WISCONSIN
UNIVERSITY OF WISCONSIN-MADISON

Subject: Docket 50-156, License R-74
License Amendment Request Regarding Administrative Controls
Proposed Changes to Technical Specifications

Proposed Changes to Technical Specifications

4. Technical Specification Figure TS-1 is currently represents the Organization Chart as shown below:

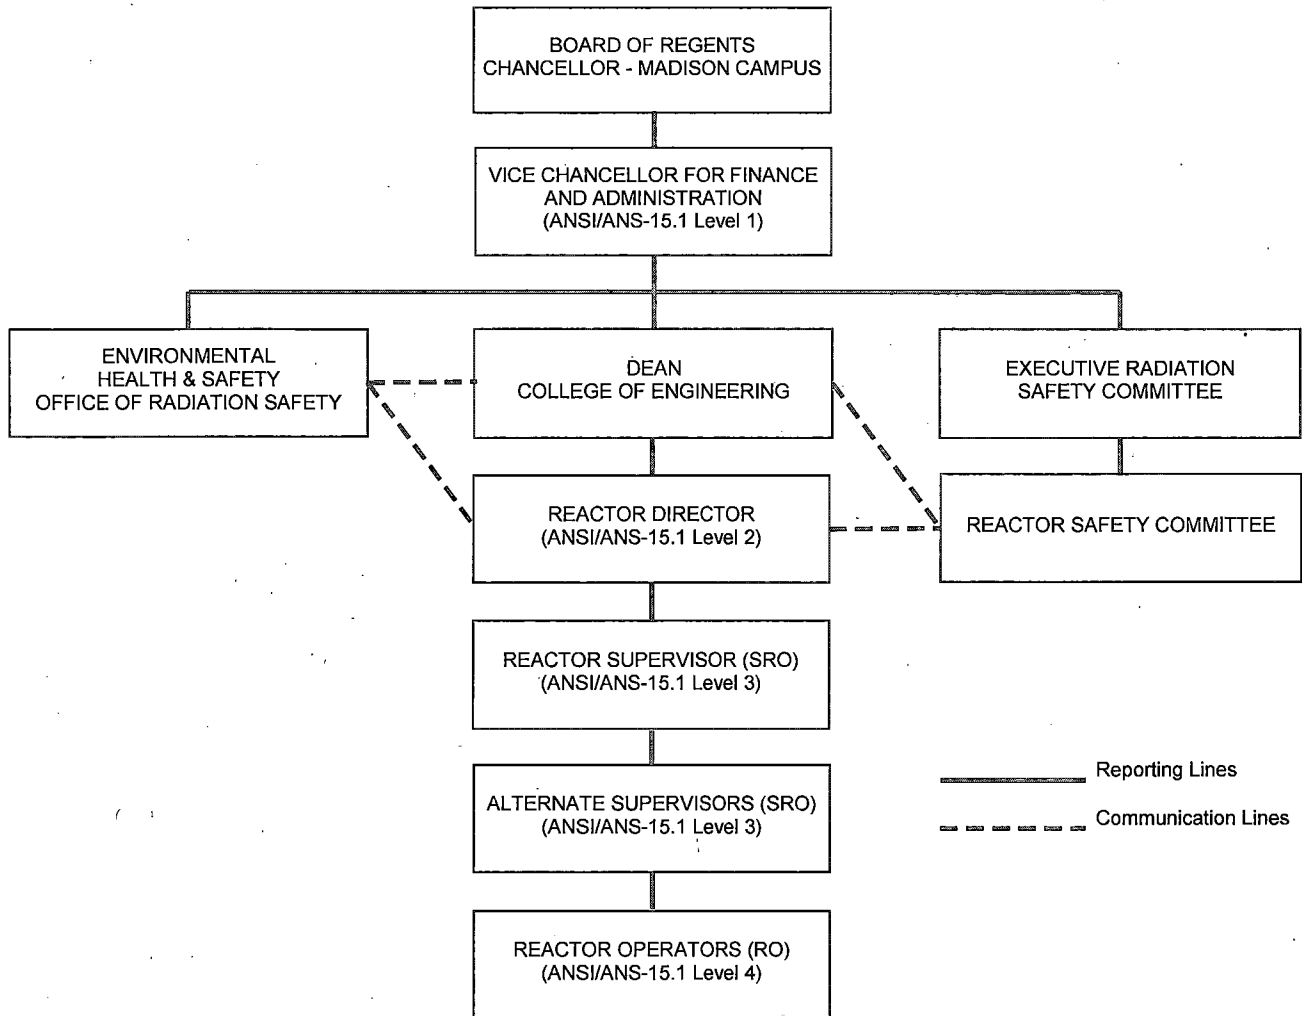
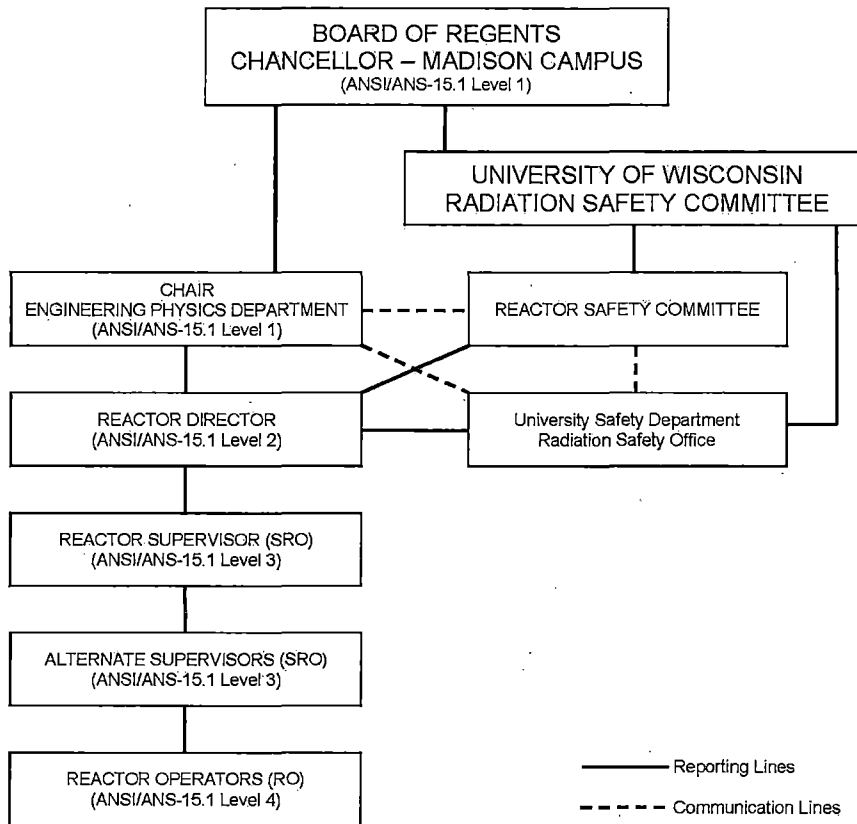
It is proposed to replace the Chair of the Engineering Physics Department with the Vice Chancellor for Finance and Administration and insert the Dean of the College of Engineering as represented below:

Basis for Proposed Change:

The basis for the replacement of the Chair of the Engineering Physics Department with the Vice Chancellor for Finance and Administration has been previously addressed in item 1 above.

The basis for the addition of the Dean of the College of Engineering has been previously addressed in item 1 above.

As required ANSI/ANS 15.1 section 6.1.1 the structure of the review and audit groups (the Reactor Safety Committee and the Office of Radiation Safety) as well as their reporting path are to be clearly identified including how these groups report to Level 1 management and communicate to Level 2 management.
